T10: Reason for Moving: This turbine has been moved to allow for the larger hardstand infrastructure to fit between water course buffers to the North and South of the location. The consented location would require a breach of these buffers.

Figure 2.12j
Infrastructure Design Review
- Turbine 10

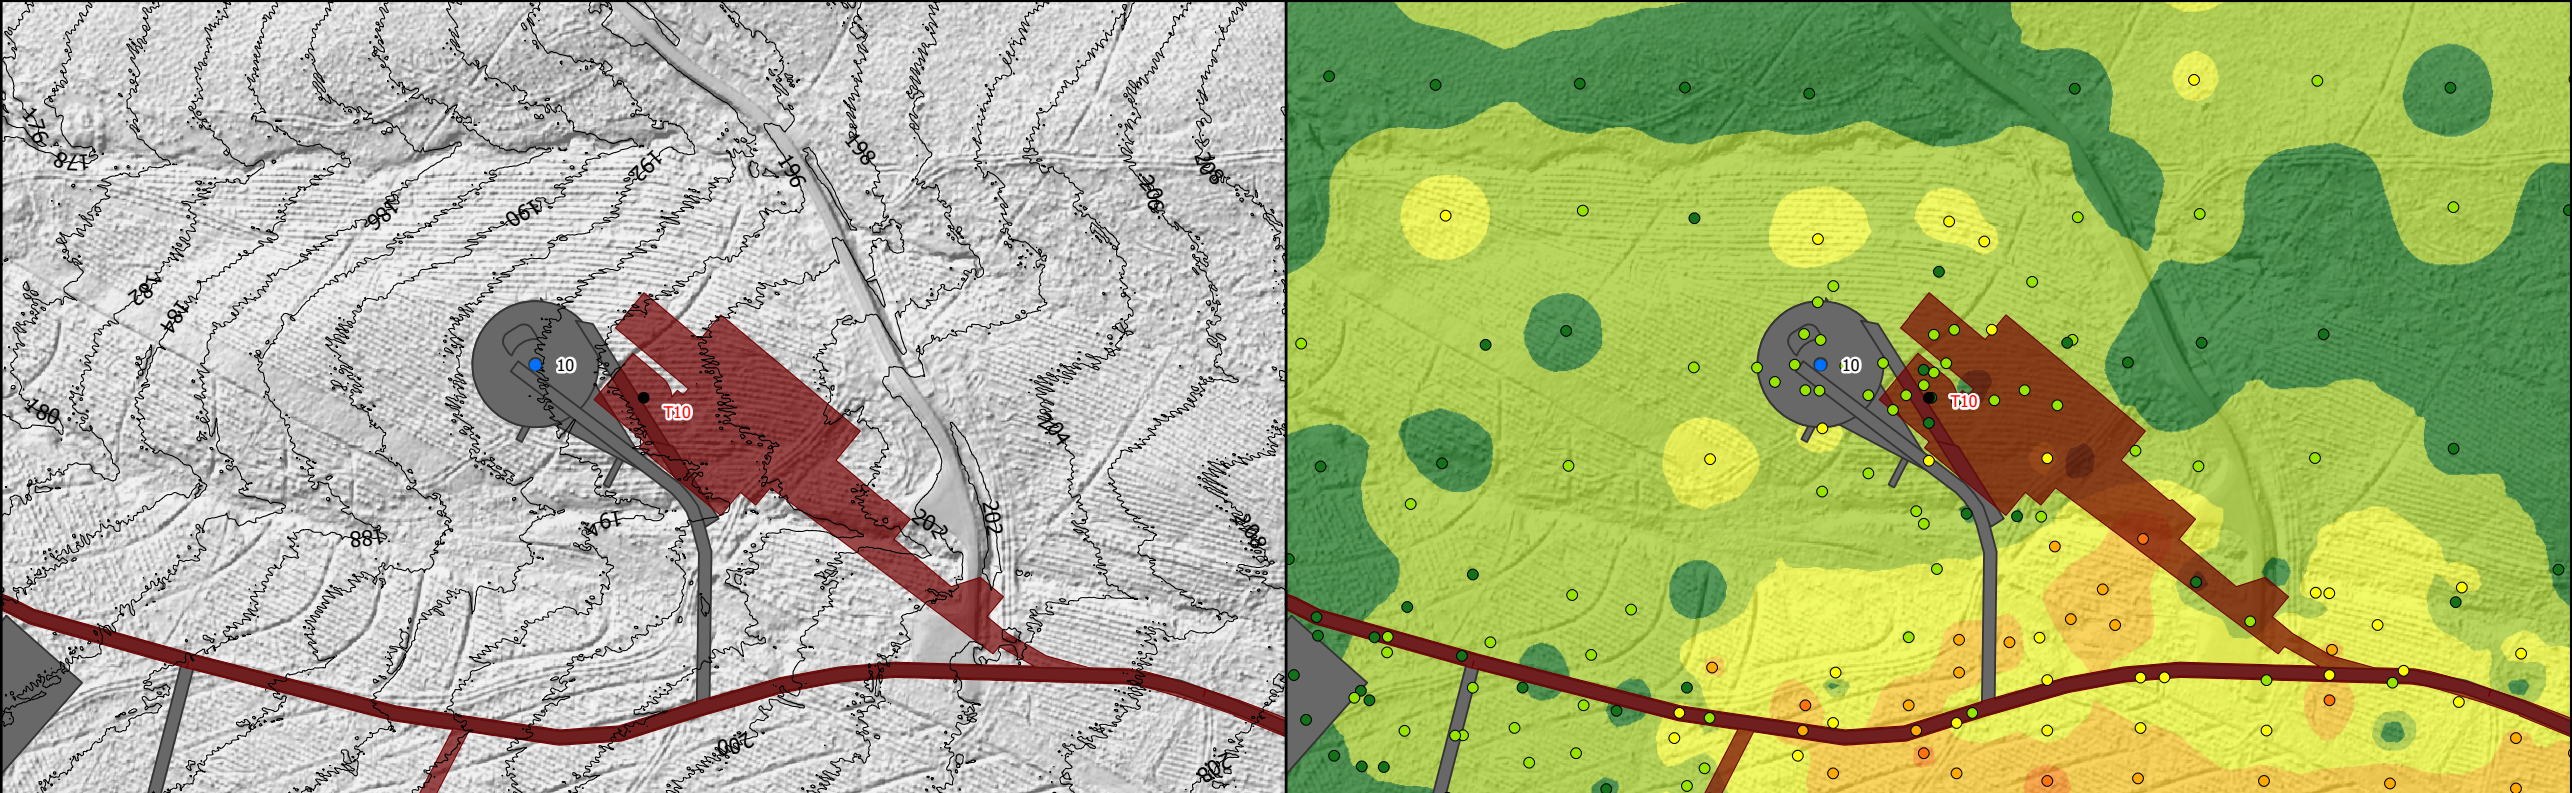
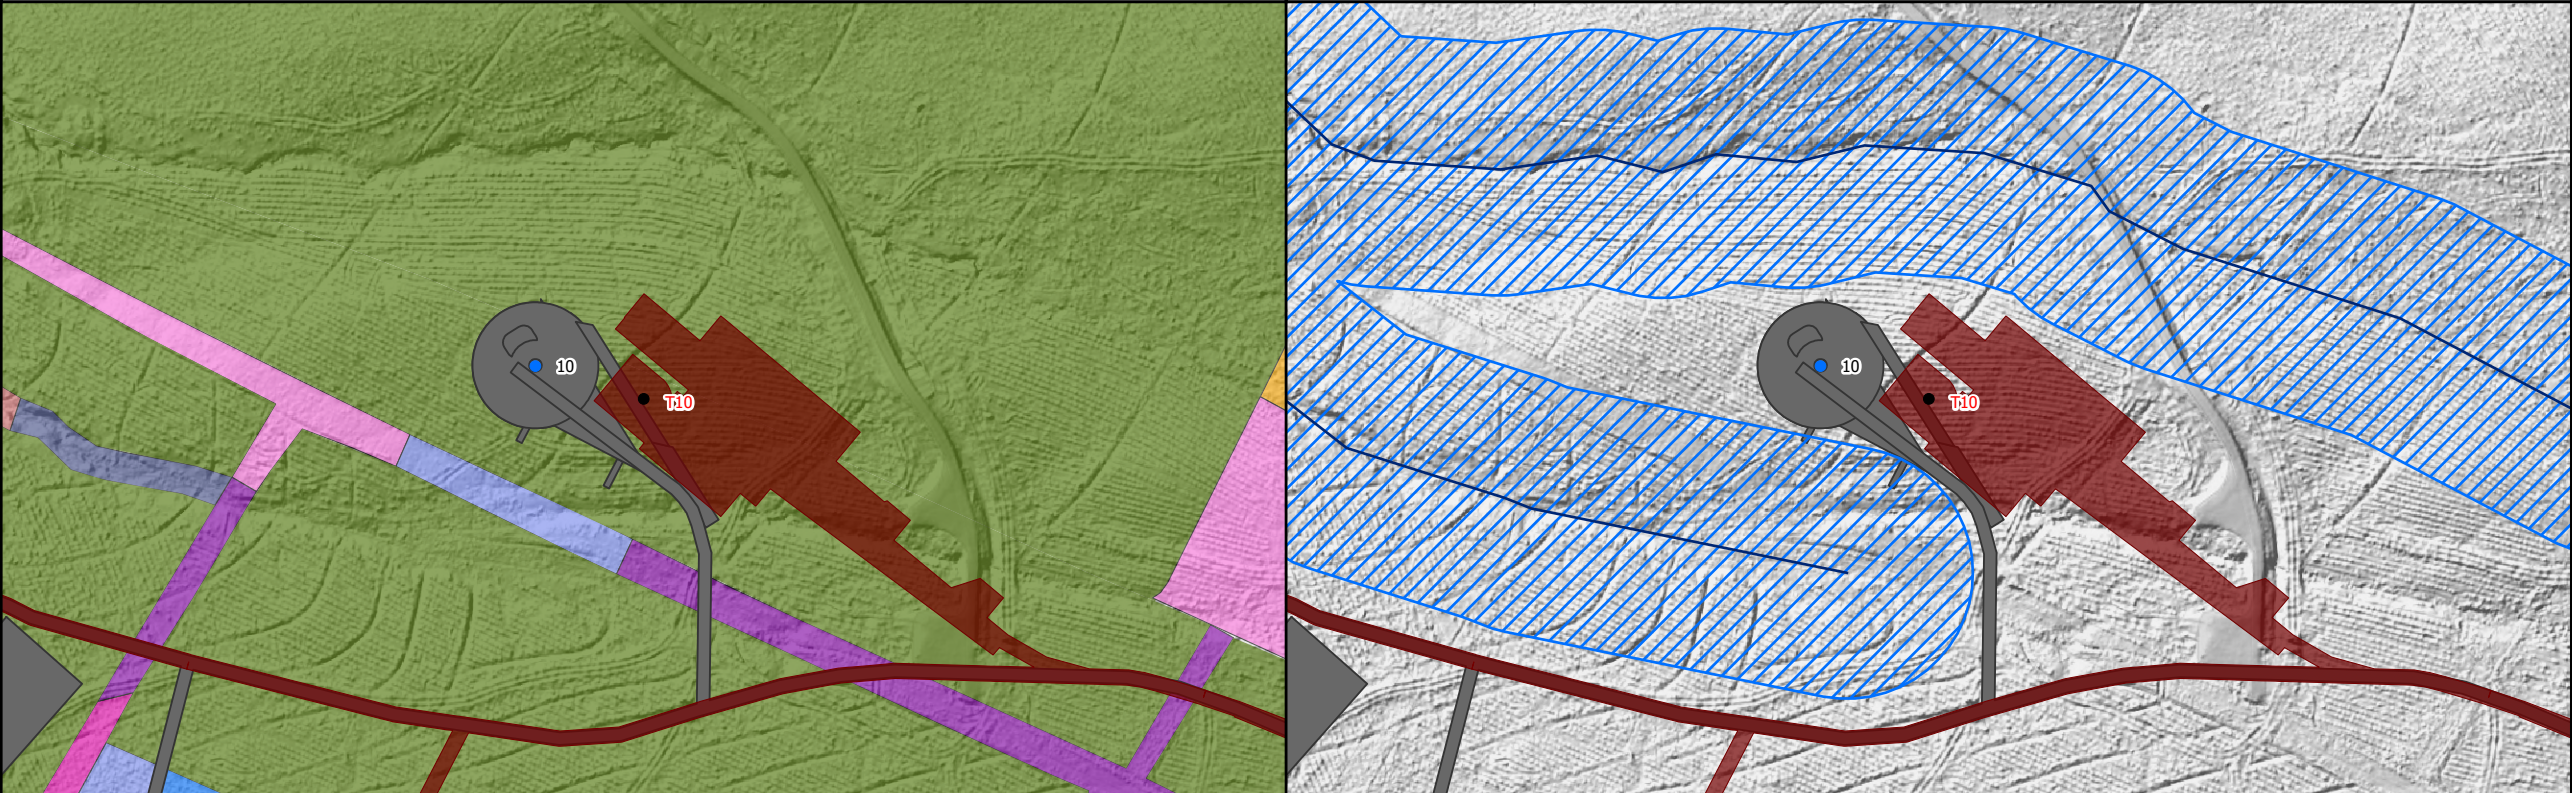
Engineering: The hardstanding and track alignment has been updated to fit with peat pockets. The consented alignment of the track would not allow for the hardstand to tie in with the track. The plan for turbine deliveries is to drive to T11 and use the loaded turning head to turn the vehicles. This will allow them to enter the T10 hardstand in a forward direction. Once unloaded the vehicles will reverse off back onto the track towards T11 and then exit the site.

Geology Impacts: The new orientation of the hardstand avoids a deeper pocket of peat that the consented layout went through. The track has been position so that peat impact is minimised as much as possible cutting between deeper areas.

Ecology Impacts: The turbine and infrastructure is located in an area that was commercial coniferous forest. The trees have now been felled. Landowner (FLS) has begun peat restoration in this area.

Hydrology Impacts: The turbine infrastructure has been place outside of 50m water course buffers to the North and South. Any microsinig during construction would be limited in this direction to ensure that this buffer is maintained. In reality microsinig would be limited to a south easterly direction.
